To:	Rachel Morgan	Job No:	1003297.6000
From:	Justine Quinn	Date:	24 March 2020
cc:	Nick Carter, Gary Bramley		
Subject:	Drury East Plan Changes - Ecology Response

This memo has been prepared to address selected ecological responses as required by the Request for Further Information (RFI) from Auckland Council for Drury East Plan Change requests by Fulton Hogan, Oyster Capital and Kiwi Property. It has been prepared by three ecologists, being Gary Bramley (for Fulton Hogan), Justine Quinn (for Kiwi Property) and Nick Carter (for Oyster Capital) and summarises the results of an ecology workshop, literature review and collaborative drafting of this response. This memo should be read in conjunction with the stormwater memo and only applies to those specific matters outlined below.

Figure 1.1: Marine SEA in the Pahurehure Inlet and wider Drury Creek estuarine area

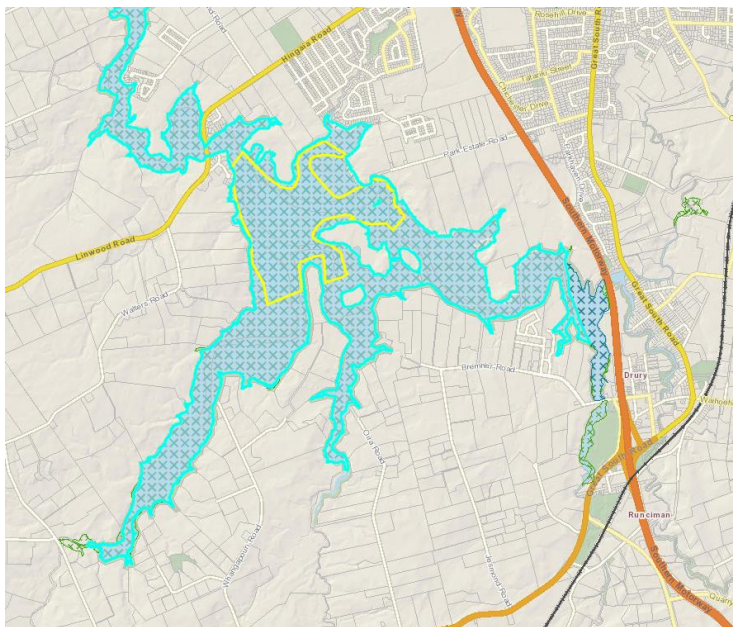
The following response has been prepared in relation to RFI E10 (Kiwi), E11 + E12 (Fulton Hogan), E10 + E11 (Oyster) which collectively request that more information is provided to assess the effects of sediment and erosion on the life supporting capacity of the marine significant ecological area.

The marine receiving environment is the Drury Creek and wider Pahurehure Inlet. The immediate marine environment is recognised as a Significant Ecological Area (SEA), which includes SEA-M1_29a, SEA-M2_29b and SEA-M2_29w1-2, shown on Figure 1.1.

Immediately adjacent to State Highway One, the intertidal area is classified as an 'SEA-M1' indicating that its physical form, scale or inherent values are considered to be the most vulnerable to any adverse effects of inappropriate subdivision, use and development. The AUP OP identifies that within these upper tidal reaches of Drury Creek there are a variety of marshes, grading from mangroves through to extensive areas of jointed rush-dominated saltmarsh, to freshwater vegetation in response to salinity changes. This same area is a migration pathway between the marine and freshwater environments for a number of native diadromous freshwater fish species.

Beyond this, the wider intertidal area is classified as an 'SEA-M2' being an area of regional, national or international significance which does not warrant a SEA-M1 identification as they are generally more robust. This has similar ecological values, but also provides roost areas of importance to wading birds including pied stilt.

NIWA were engaged by the Ministry for the Environment to develop and apply a new empirical model that estimates mean annual river suspended sediment load and sediment deposition in coastal hydrosystems³. The model includes suspended sediment load and inherently includes sediment supply from eroding streambanks as well as upstream hill-slope erosion processes.

Shallow drowned valleys such as the Pahurehure Inlet have intermediate level deposition rates (median of 0.7 mm/year), where near-bed velocities are low, little resuspension by currents occurs, and a main channel morphology tends to be absent. The trapping efficiency of a shallow drowned valley is typically quite high, and the Pahurehure Inlet has a predicted trapping efficiency of 0.963. Trapping efficiency is the proportion of incoming sediment load that is retained and settles within the water body measured on a scale of 0 to 1, where 1 means that 'all river-sourced sediment is

retained in the coastal hydrosystem'. What this tells us, is that the marine receiving environment is a natural deposition zone and sediment deposition is expected and required for the environment to continue to function.
